*Report for a Constructability Review
& a Value Engineering Study
For the Issaquah School District*

ISSAQUAH
SCHOOL DISTRICT 411

For Elementary School No. 15

May, 2009

VE PROPOSAL No. 5: IDEA No. 74 - Use the same expenditure now planned for draught tolerant plants only without an installed irrigation system.

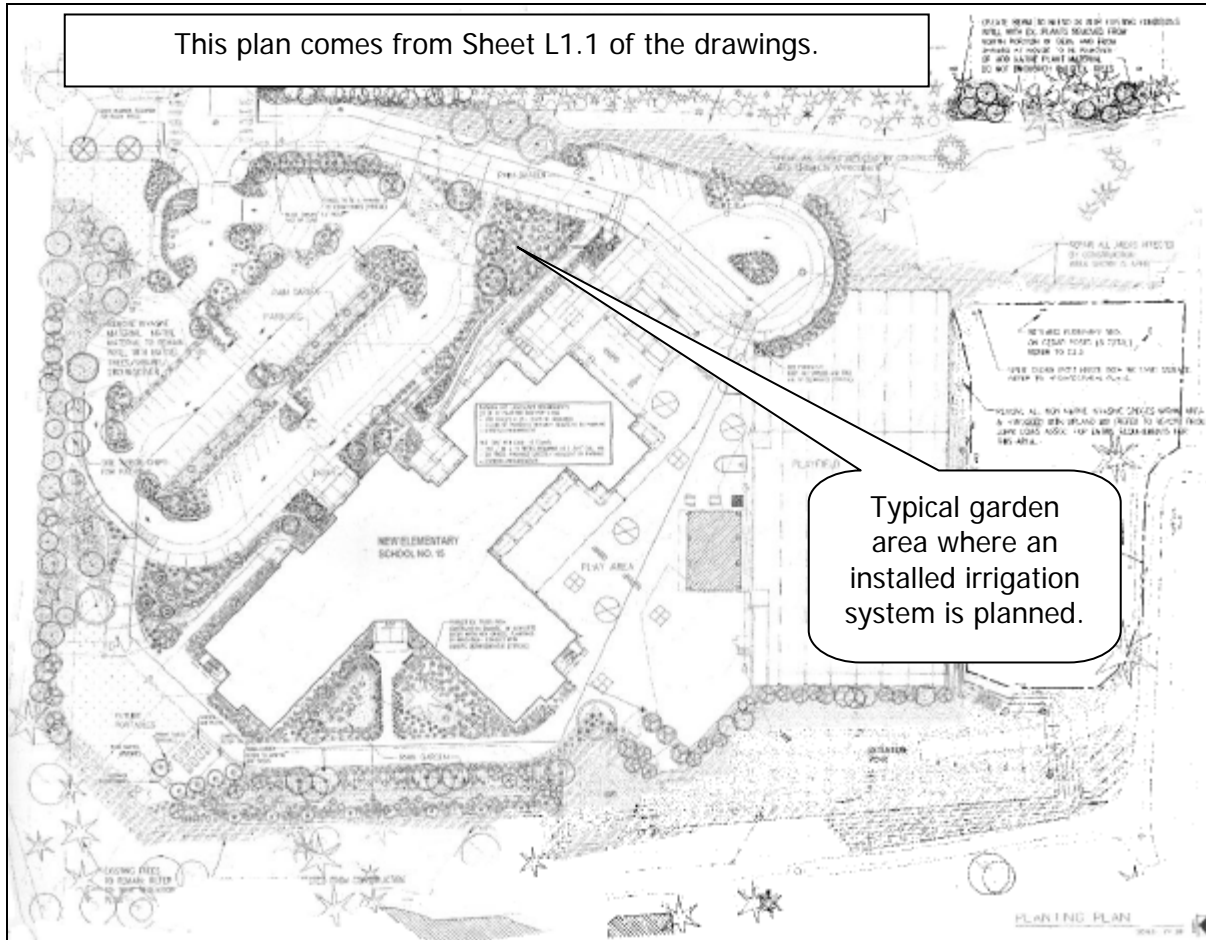
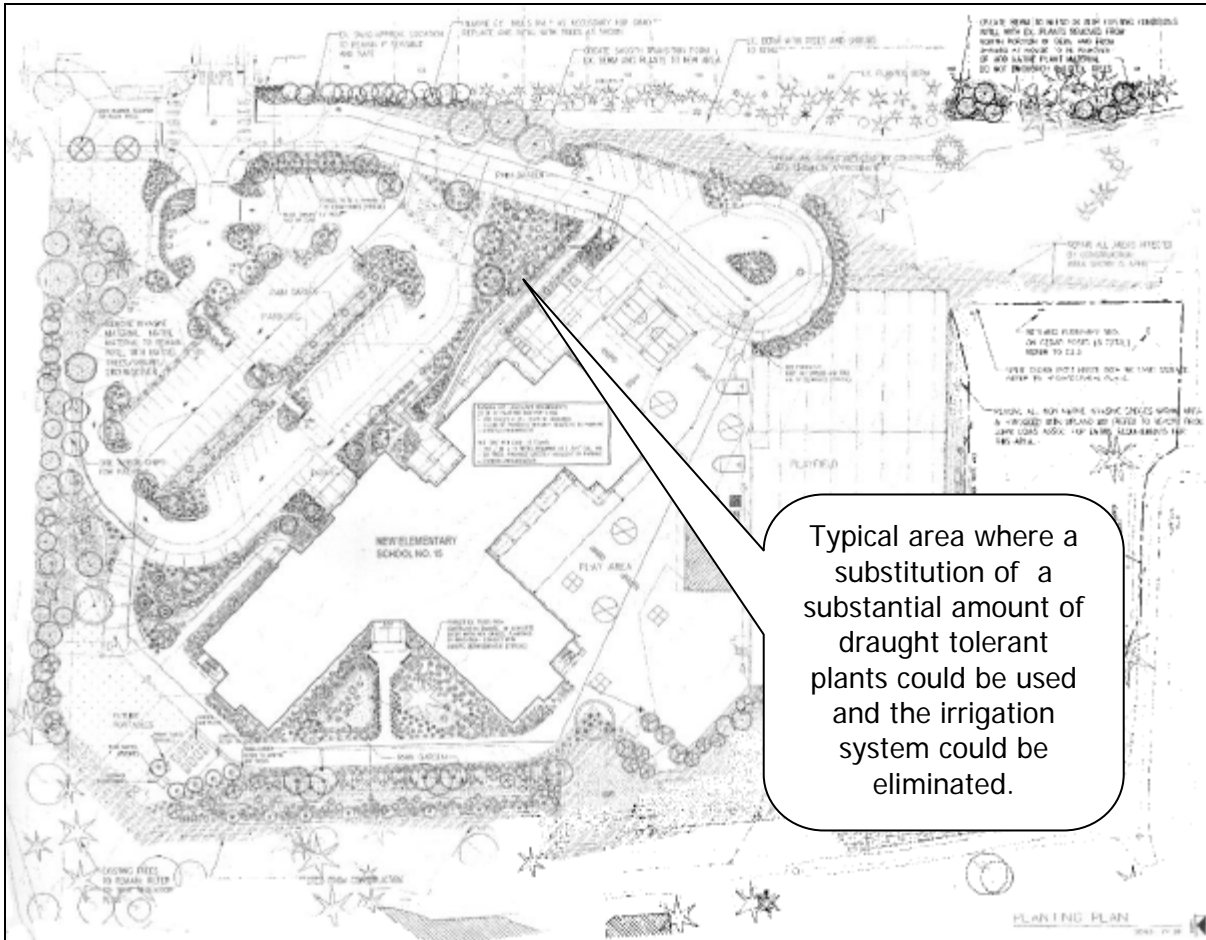
The design now shows a permanent irrigation system that is planned for the garden areas of the site. This is a typical design for many facilities.

The design element selected for study is the permanent irrigation system that is planned for the garden areas of the site. Some owners have found that the use of drought tolerant plantings can provide an acceptable solution that also shows the community a consideration for conservation of resources with regard to the amount of plantings and the requisite maintenance associated with a conventional irrigation system. This proposal is similar to VE Proposal No. 4, but it totally eliminates the irrigation while maintaining the original expenditure for the amount of plantings. Maintenance costs have been maintained at the same amount as VE Proposal No. 3, and there may be an opportunity for greater life-cycle savings.

This Partial East Elevation comes from Sheet A3.1 of the drawings, view No. 1.

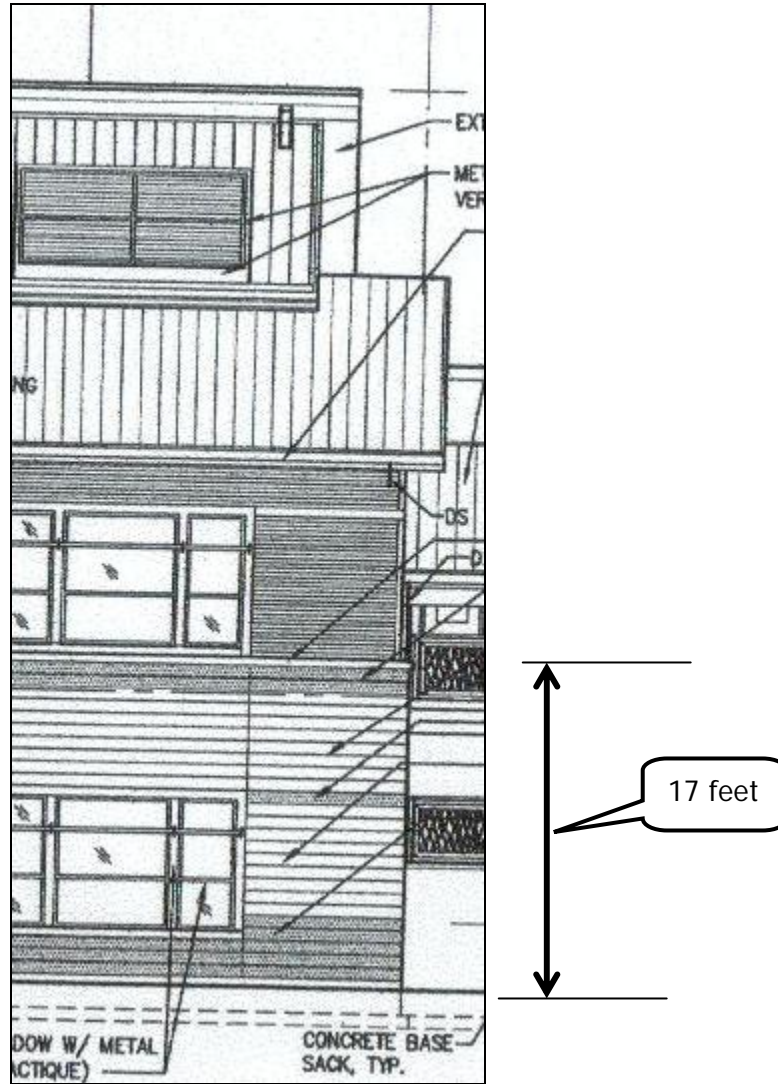
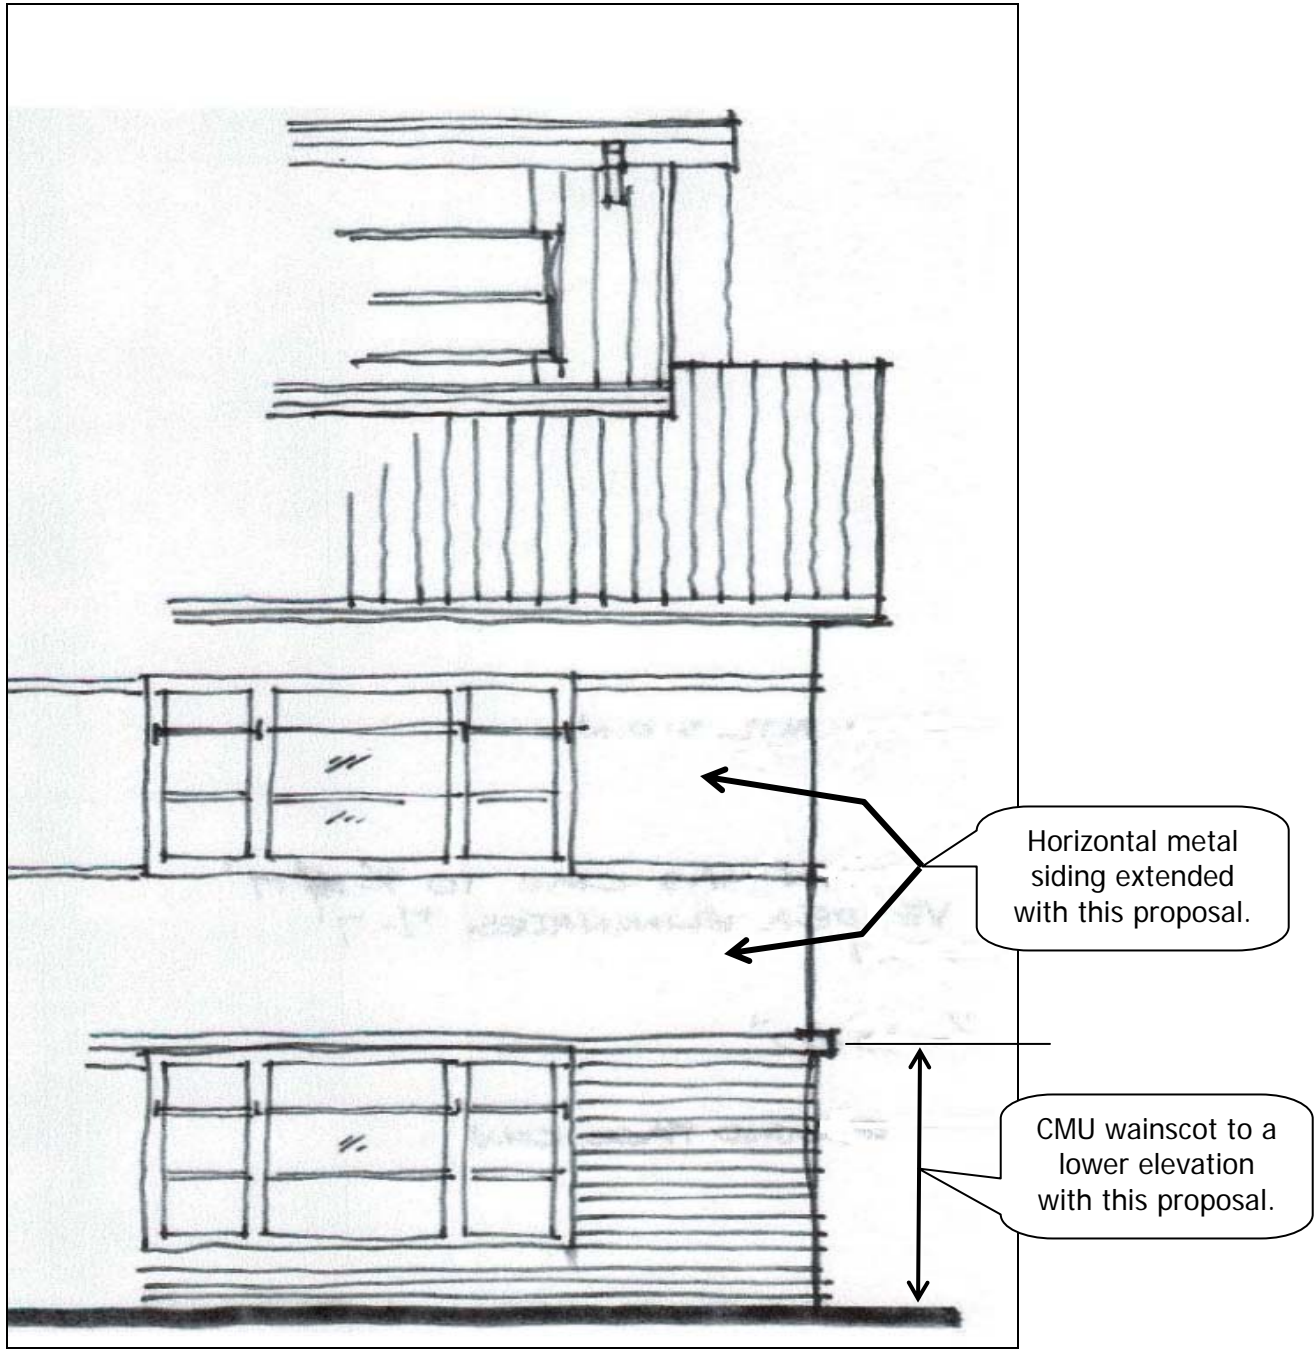
The design now shows a change in the exterior façade at about 17 feet where the CMU wainscot transitions to the metal siding that is located above the CMU.

This proposal by the CR&VE Team suggests that the CMU wainscot could be used to an elevation of about 8 or 9 feet instead of the 17 feet in the current concept. This would extend the metal siding that currently begins about the 17 foot level down to the 8 or 9 foot level. There is a modest savings in capital cost by implementing this proposal.

6.	Idea No. 094. The current design shows a height of the CMU wainscot at 17-feet +/- . The CR&VE Team suggests that this could be reduced to 8 or 9 feet.	Exterior design, approved by the City, would be changed significantly and require additional City review. Delay to start of construction outweighs potential savings
